Response of Squibnocket Farm, Inc. to Chilmark Conservation Commission Questions

Submitted: January 18, 2016

The following responds to the written questions that the Conservation Commission directed to Squibnocket Farm, Inc. on January 8, 2016 (as revised January 12, 2016). The Commission's question is repeated, followed by our response. Capitalized terms not defined below have the meaning given to them in the Notice of Intent (NOI):

ERC-1

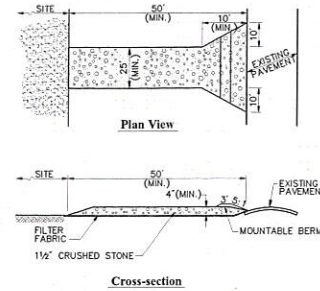
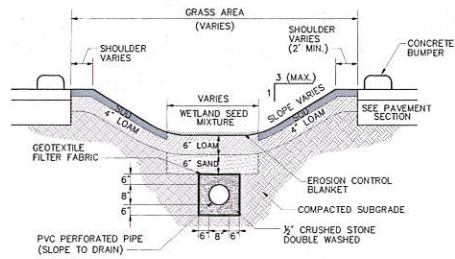
4. *Please indicate the limit of work and placement of erosion control barriers for the roadway and causeway activities.*

Response: Limits of work and associated erosion controls are illustrated on NOI Plan Sheet ERC-1. A revised version of this sheet, showing limits of work within the Low Causeway section of the Project, is submitted with these responses.
